**Subject: Notice of Alteration – RM of Gimli Biosolids Storage Facility**  
**Client ref.: File no. 4522.10**

## NOTICE OF ALTERATION

**TO:** Shannon Kohler, Director – Conservation and Climate, Environmental Approvals  
**FROM:** Dana Bredin, P.Eng. – WSP Canada Inc.  
**SUBJECT:** RM of Gimli Biosolids Storage Facility  
**DATE:** March 25, 2021

Figure 1: Proposed Operational Changes

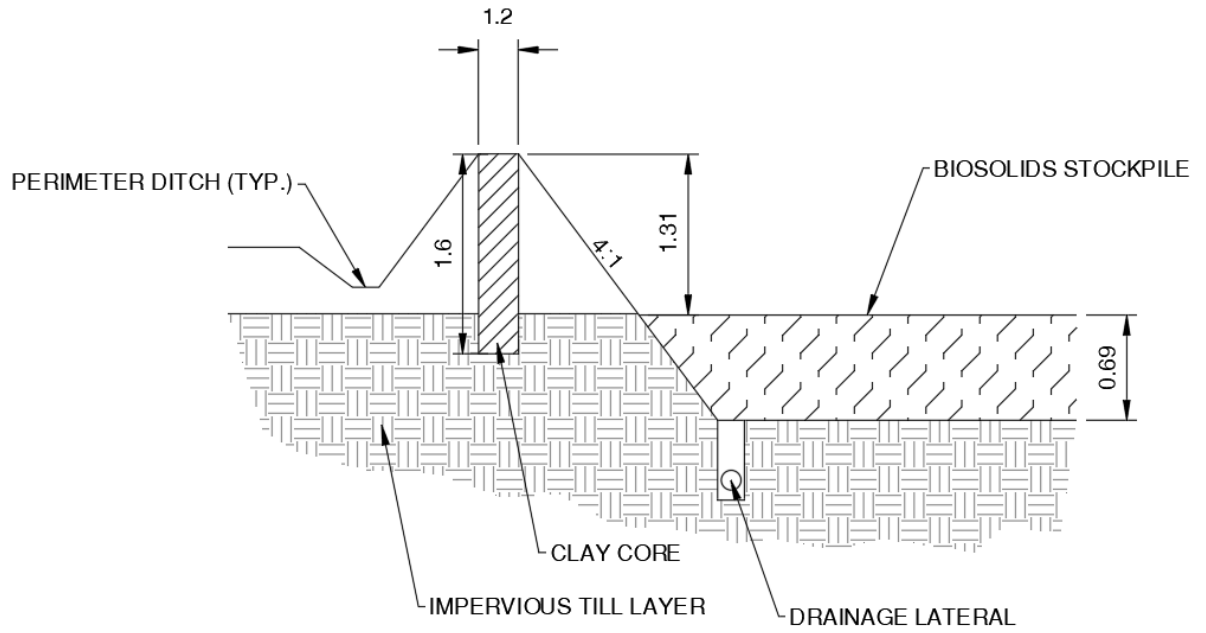
Currently, biosolids are to be stored in the cell up to a depth of 1.0 m while maintaining a freeboard of 1.0 m. The design allowed for biosolids to be stored on the berm slopes. Each cell is anticipated to be used once every three years and will store the biosolids for up to 18 months before land application.

We propose to modify the stockpile height of the dewatered biosolids material in the storage cells. The maximum height of the biosolids will be reduced to 0.69 m. This change allows for the material to be stored entirely within the in situ till layer and mitigates any potential impact of collected water moving laterally through the clay core.

The revised storage capacity of each cell is approximately  $1,460 \text{ m}^3$  for an overall capacity of approximately  $8,760 \text{ m}^3$ . From the EAP submitted in March, the anticipated future biosolids generation per year is  $4,270 \text{ m}^3$ , thus there is still over two years of capacity at the storage facility when the WWTP reaches its design capacity.
